Access Compliance Report

Public Rights-of-Way

(Curb Ramps)

Intersection ID: 7979	Main Street: EAGLE PEAK DR	Cross Street: DAVID AV	Location: W
ADA ID: DBF43EF65C2D	Ramp Type: Perp	Initial Pass/Fail: Fail	Overall Compliance: No
			Severity Score: 33.75

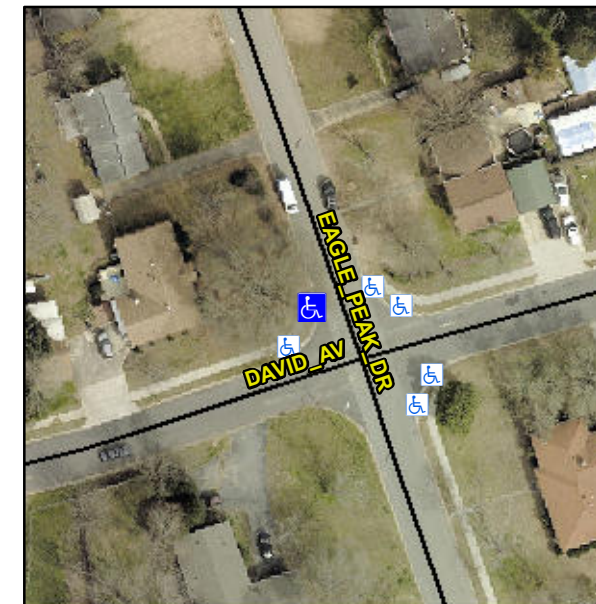
Not Found, R304.5.1, R304.2.2, R304.5.3

Compliance	Description	Data	Compliance	Description	Data
N/A	Ramp Length (in)	48.0	No	Ramp Slope (%)	8.4
No	Ramp Width (in)	46.5	No	Ramp XSlope (%)	6.1
N/A	Flare Type LT	N/A	N/A	Flare Type RT	N/A
N/A	Flare Slope LT (%)	N/A	N/A	Flare Slope RT (%)	N/A
N/A	Flare Traversable LT?	N/A	N/A	Flare Traversable RT?	N/A
N/A	Landing Length (in)	N/A	N/A	DWS Provided?	N/A
N/A	Landing Width (in)	N/A	N/A	DWS Contrast?	N/A
N/A	Landing Slope (%)	N/A	N/A	DWS Length (in)	N/A
N/A	Landing X Slope (%)	N/A	N/A	DWS Full Width?	N/A
N/A	Landing Curb? (Y/N)	N/A	N/A	DWS Offset (in)	N/A
N/A	Shared Landing?	N/A			
N/A	Gutter Ponding?	N/A	N/A	Gutter Slope (%)	N/A
N/A	Gutter Lip Ht (in)	2.0	N/A	Gutter X Slope (%)	N/A
N/A	Painted X Walk1?	No	N/A	Painted X Walk2?	N/A
	X Walk 1 Direction	To E		X Walk 2 Direction	N/A
N/A	X Walk 1 Width (in)	N/A	N/A	X Walk 2 Width (in)	N/A
	X Walk 1 Slope (%)	0.4		X Walk 2 Slope (%)	N/A
	X Walk 1 X Slope (%)	5.5		X Walk 2 X Slope (%)	N/A

Remove & Replace Entire Ramp.
